Attachment A

20.10.200 Suburban Residential Districts (R-2.5, R-3.5, R-4, R-5).

8. Build Compatible Parking Structures.

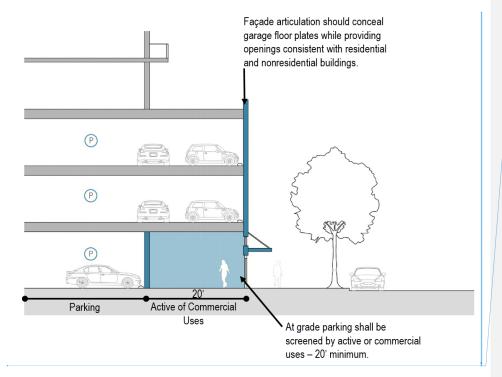
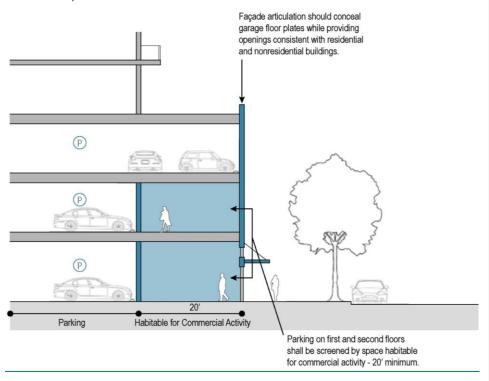
Commented [A6]: Topic 2. Internal LUC Consistency and Clarity

Graphic updated to reflect code, which states in LUC 20.25A.170.A.8.b.i that "first and second floors shall be habitable for commercial activity" instead of first only
